TECHNICAL APPENDIX 3.3: TURNING AREAS SAFETY AUDIT

Kirkton Energy Park
Prepared for: Kirkton Wind Farm Ltd

STAGE 1-2 ROAD SAFETY AUDIT

Kirkton Wind Farm

Appendix C

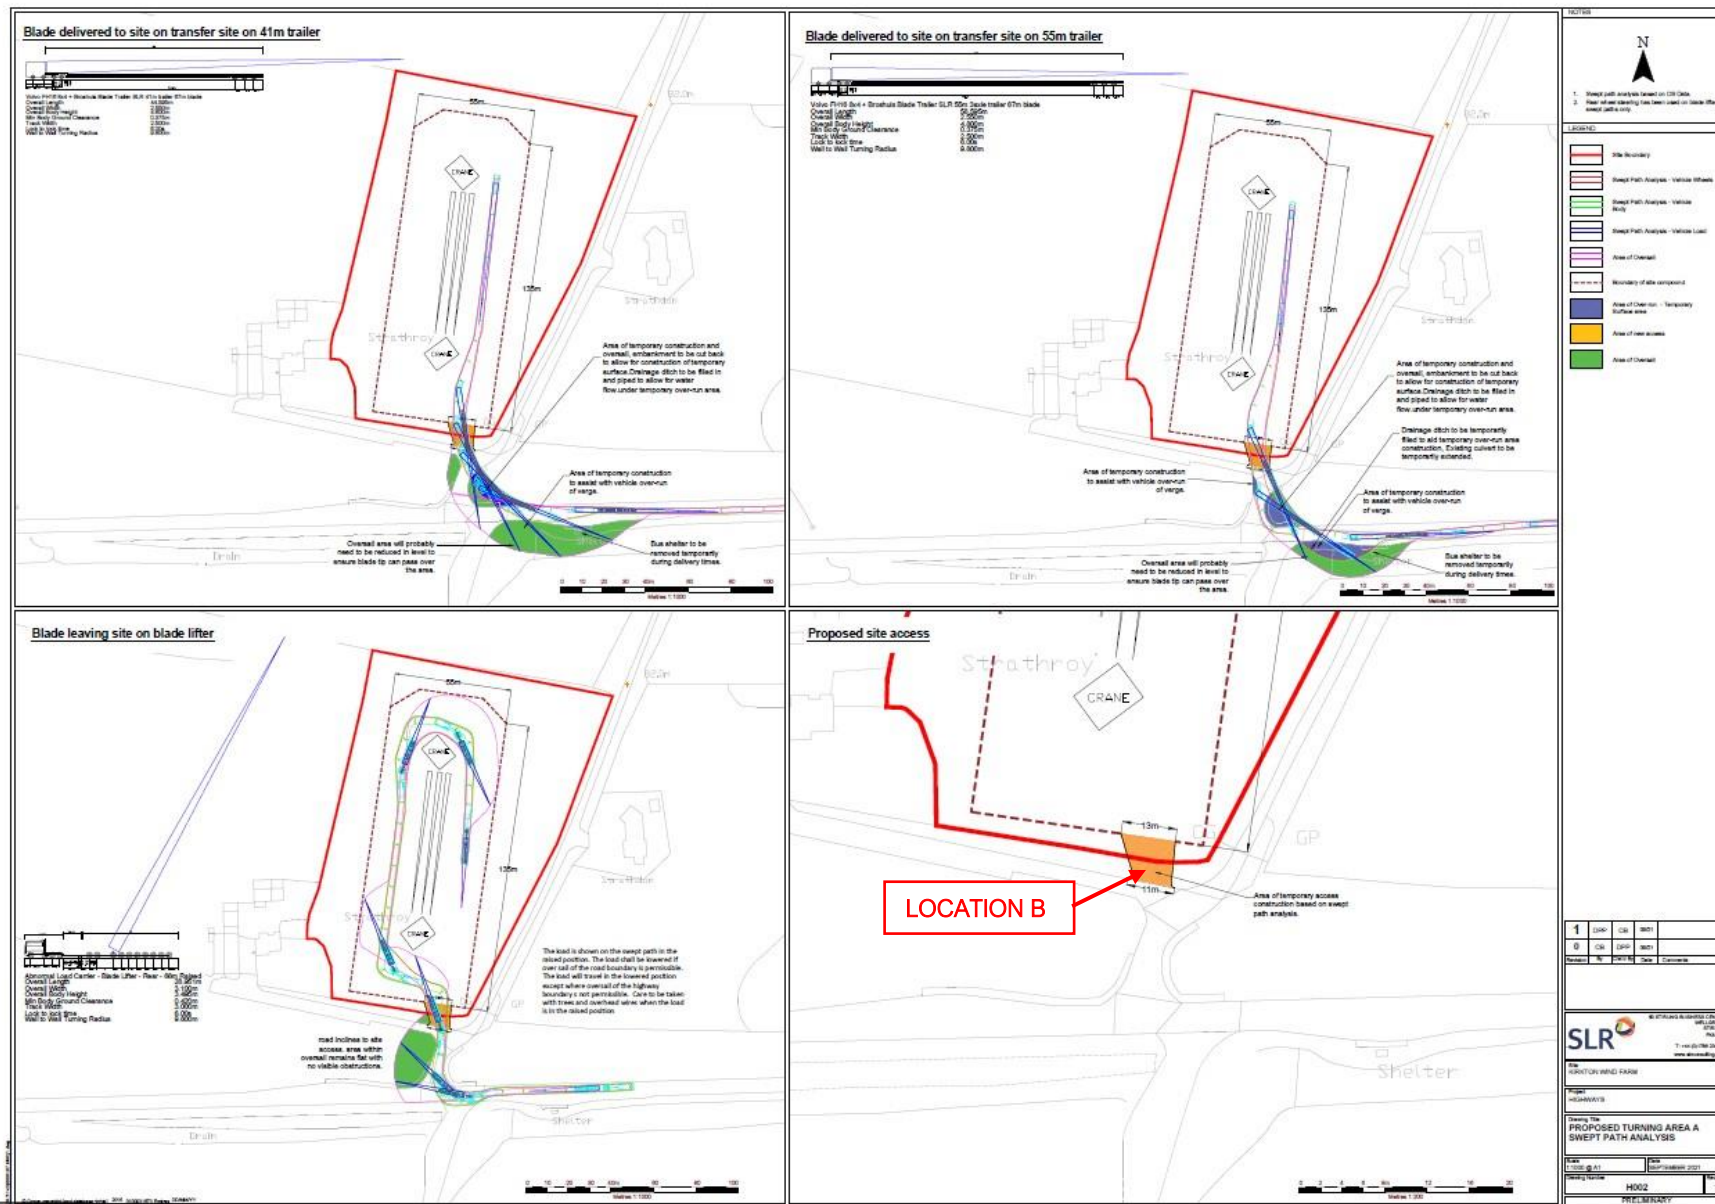
Location A: Melvich Village site access.

Summary: Restricted visibility from the access may lead to collisions with approaching traffic.

No visibility splays have been provided for this site, and while sight lines are generally good, a tree on the western side of the proposed access may inhibit visibility in this direction, particularly for site staff in normal vehicles leaving the site, resulting in collisions with eastbound traffic.

Location B: Strathy site access.

Summary: Existing chamber in access may become a slip hazard or may collapse.

The proposed access point coincides with an existing chamber with a metal cover. This is on a slope and may become slippery with use causing site traffic to lose control. Further, the overrunning of the chamber by heavy traffic may cause it to collapse risking injury to operatives.

It is recommended that the visibility splays are cleared of obstructions.

It is recommended the chamber and cover are relocated, or reinforced, with a skid resistant cover.
